Sea Link Grid Reinforcement
Pre-Submission Engagement
Suffolk County Council Response

January 2025

Sea Link Pre-Submission Engagement
Suffolk County Council Response
Appendix B: Benhall Railway Bridge
Structural Review Report

Sea Link Pre-Submission Engagement
Suffolk County Council Response
Appendix C: Benhall Railway Bridge
Principal Inspection Report

DIAGRAM D1 – BRIDGE SOFFIT

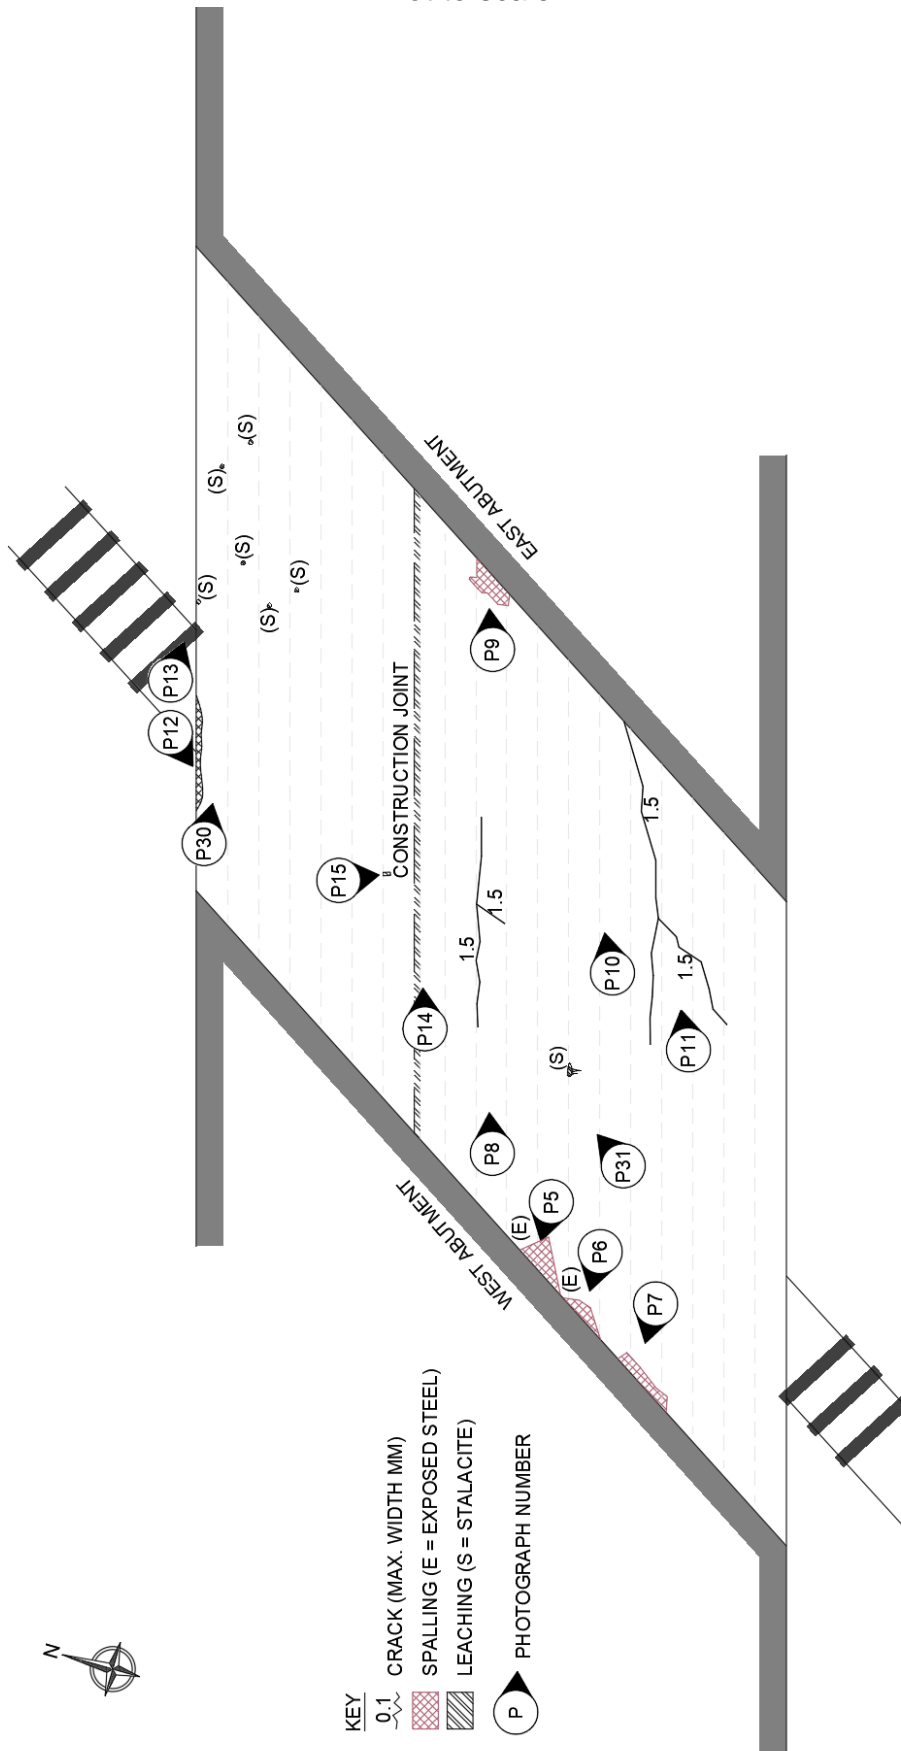
Expose the steel beam around the affected area (to clean steel), remove corrosion product and prepare to bright clean steel. Apply anti-corrosion paint to the steel, prior to concrete repair for long term durability.

DIAGRAM D2 – WEST ABUTMENT
Not to scale

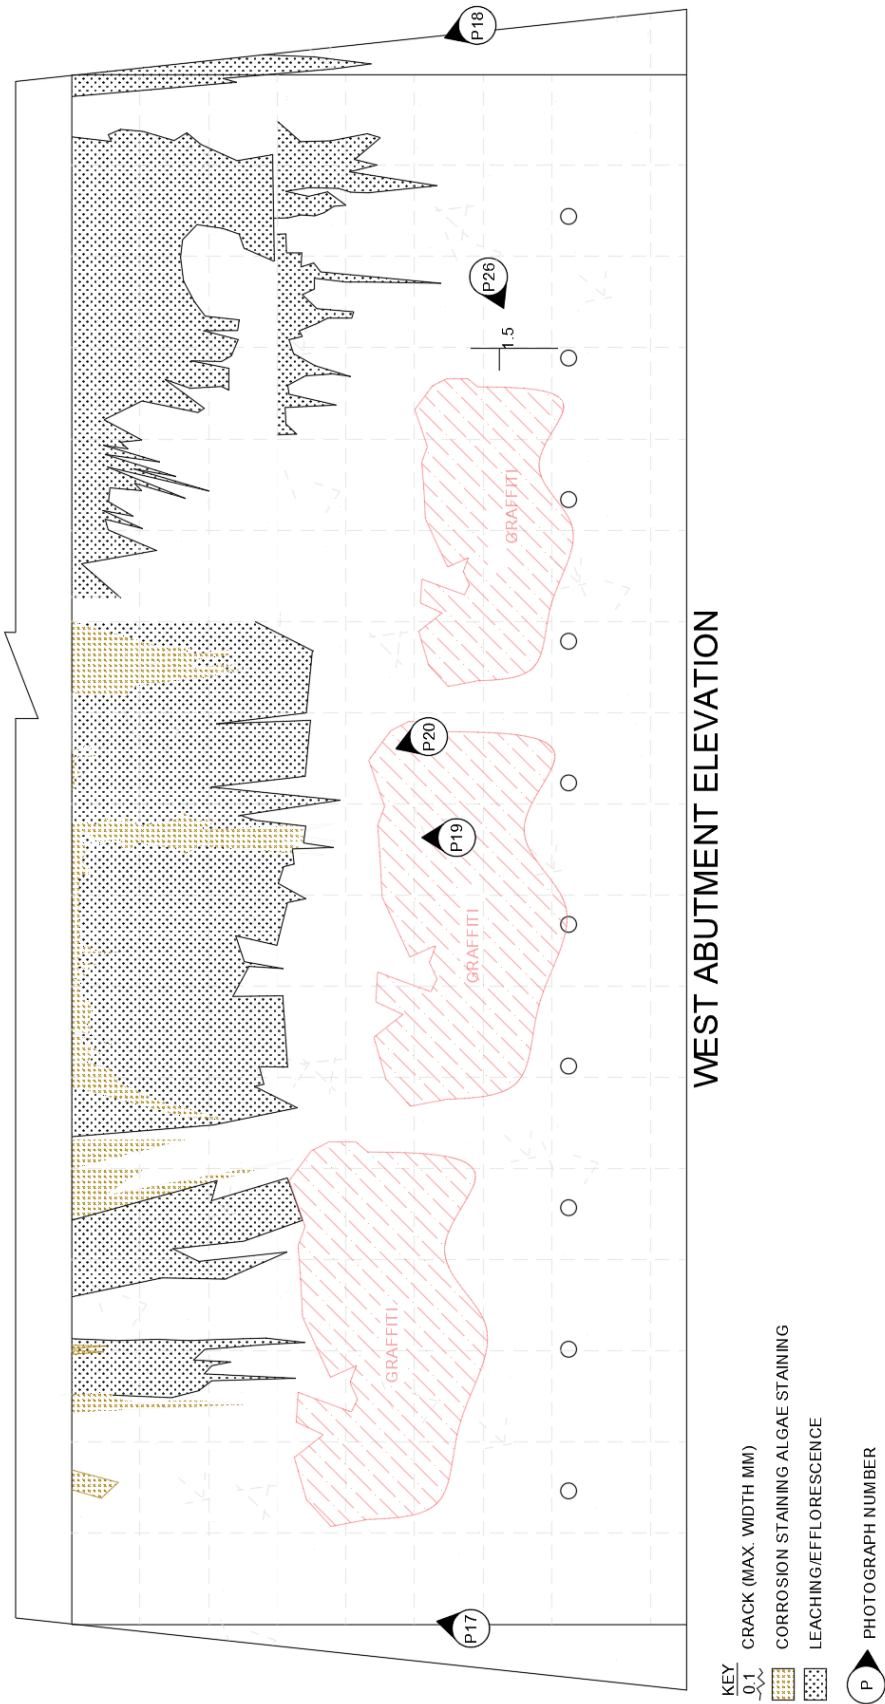
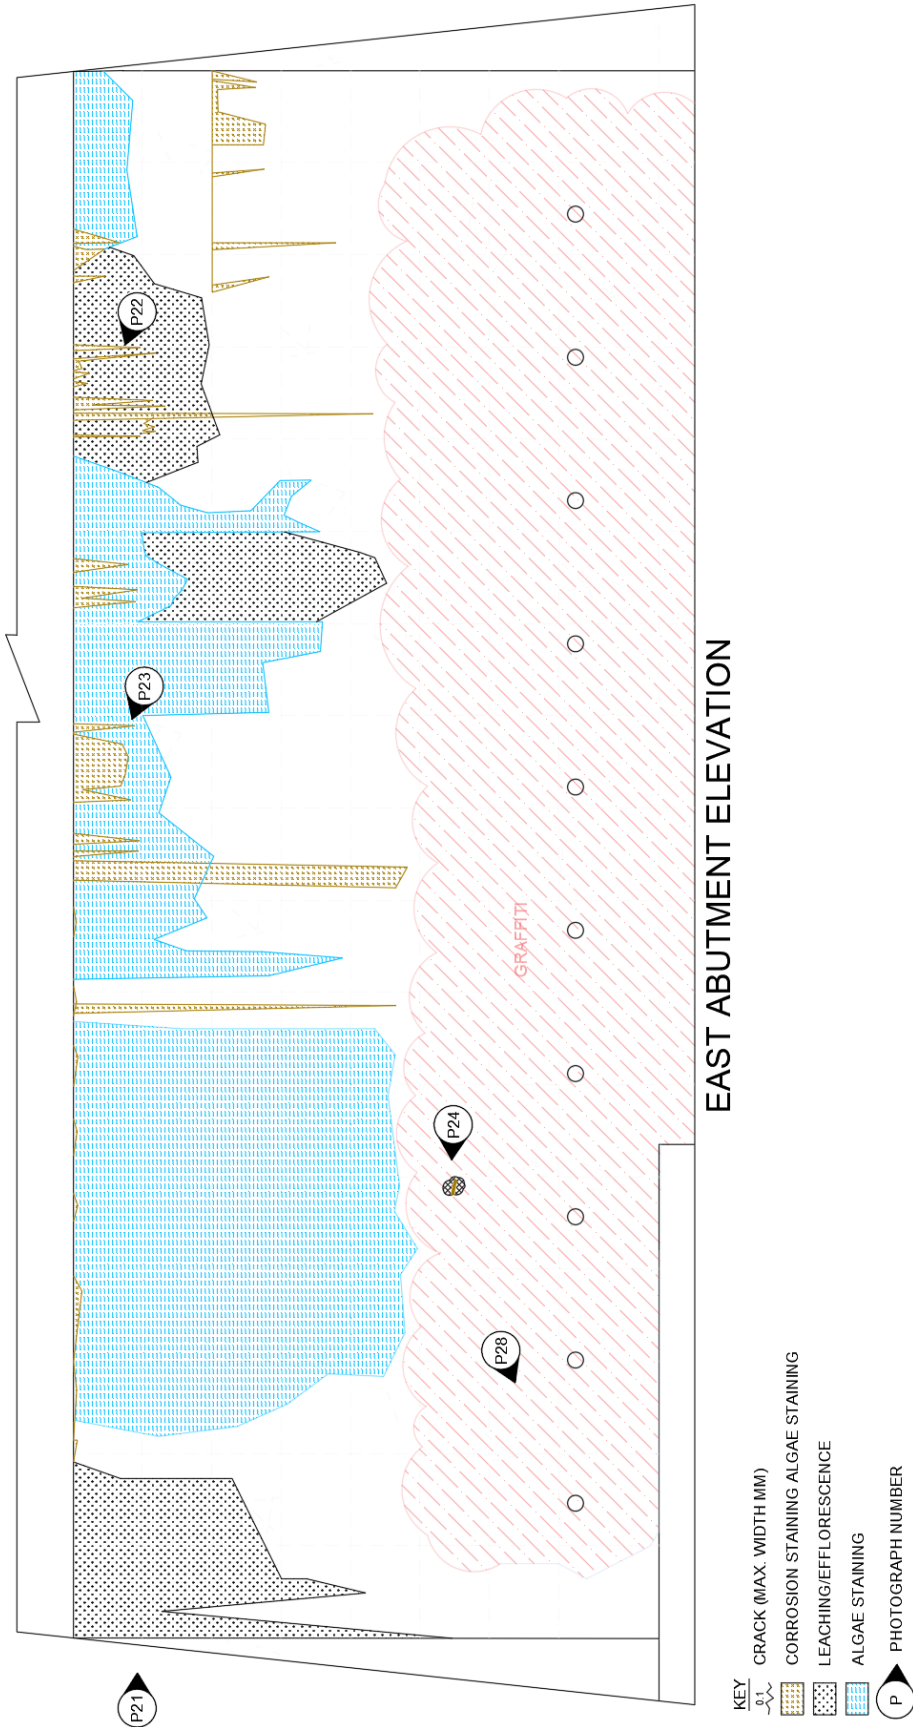
The previous report noted leaching and water stains at the top of the abutment. The staining observed on the abutments are likely due to expansion joint failure allowing water/moisture to percolate through the deck/abutment construction forms, over the bearing shelf and down the abutment face (it should be noted that the construction detail and presence of bearings is unclear from the as-built drawings provided. It appears that there is no movement permitted in the design of these elements). The noticeable lines of Saline deposits to the abutment face at lower levels are likely result of the steps in mass concrete construction form of the abutment and water/moisture percolating through these cold joints.

No action required.

DIAGRAM D4 – NORTH & SOUTH PARAPET

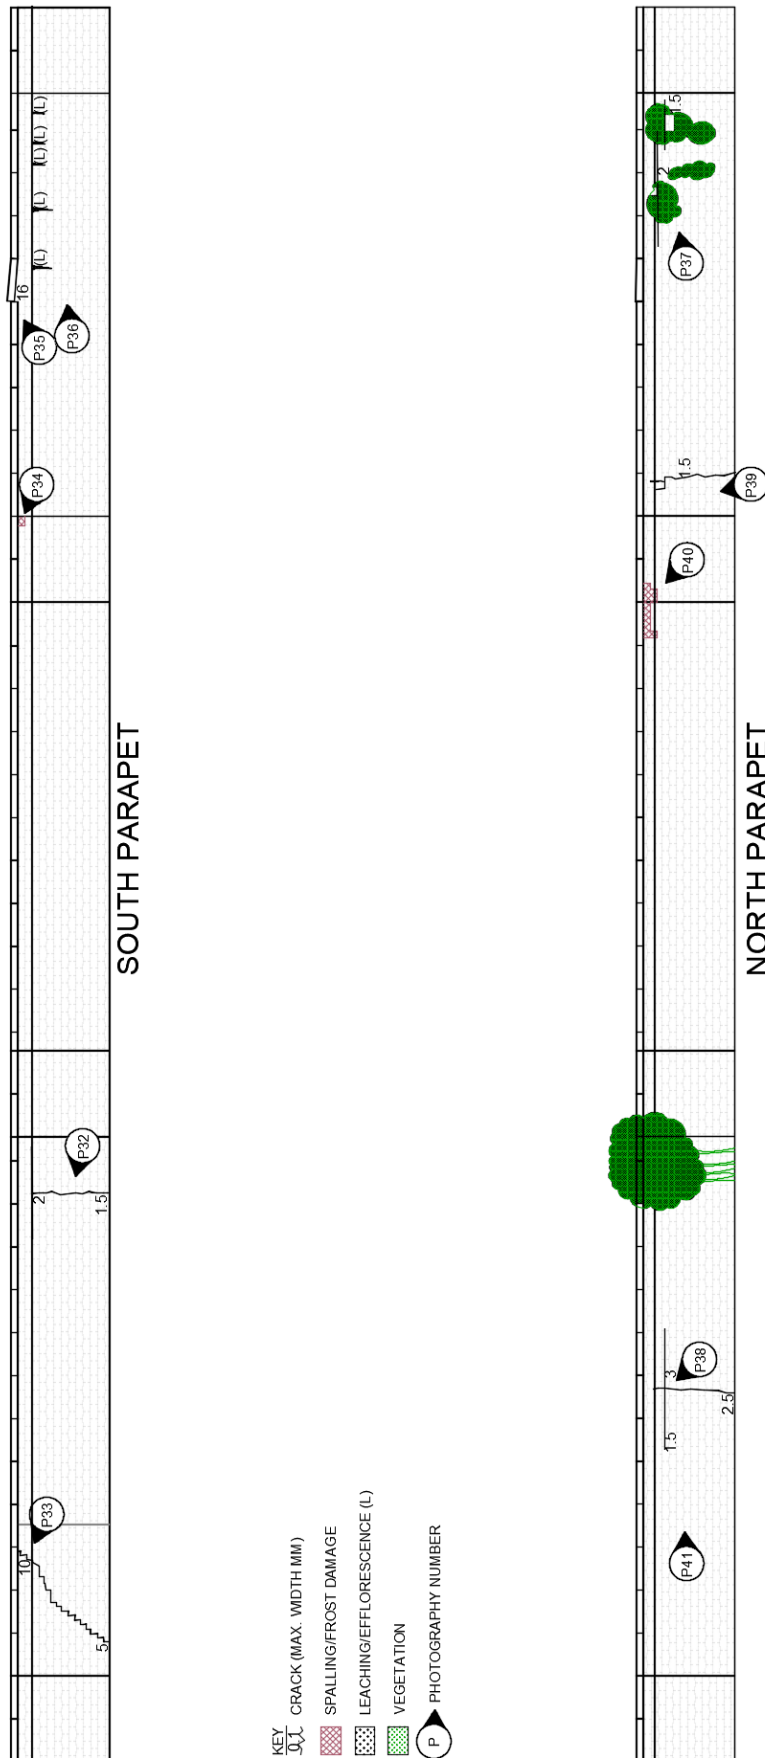
Light vegetation removal (strimming) was undertaken before the inspection, however it was not possible to remove all vegetation due to the time of year falling within the bird nesting season. Full vegetation removal is recommended prior to the next inspections.

Remove vegetation from parapets prior to next Principal Inspection.

DIAGRAM D5 – WINGWALLS

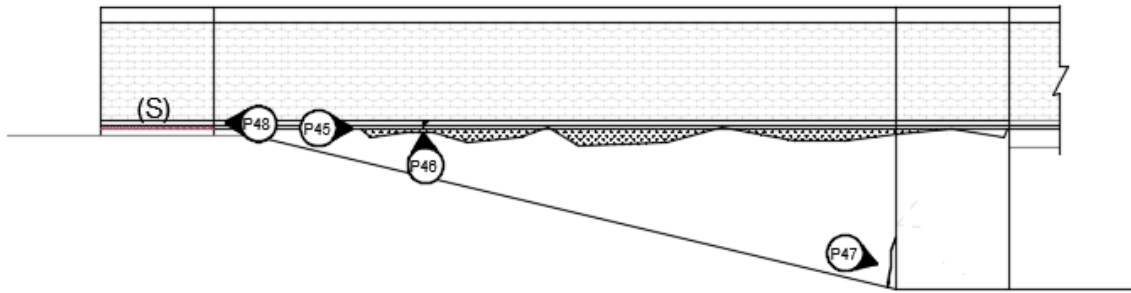
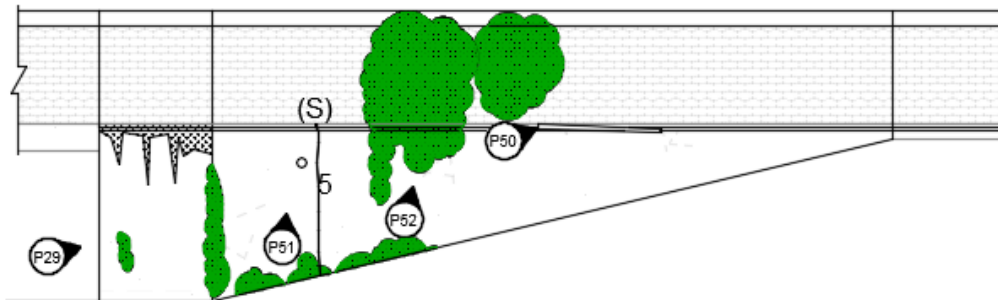
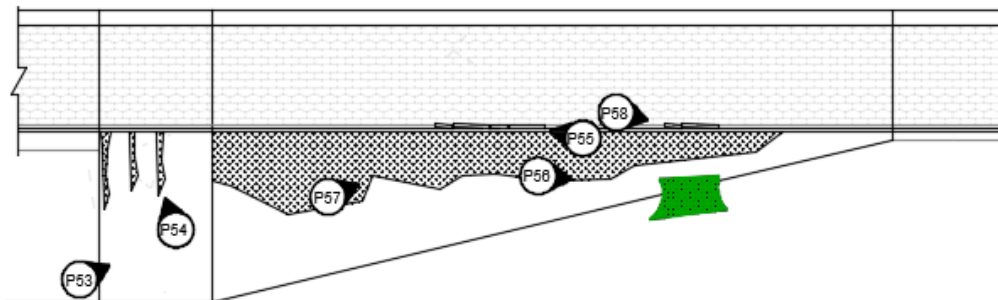
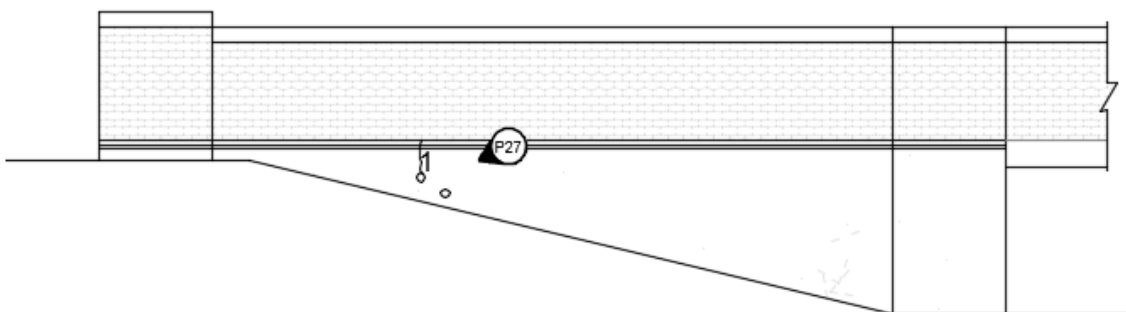
The previous inspection incorrectly numbered the wingwalls as reinforced concrete elements, they are shown as being mass concrete on the as-built drawing.

Work action:
Monitor crack widths at next inspection.
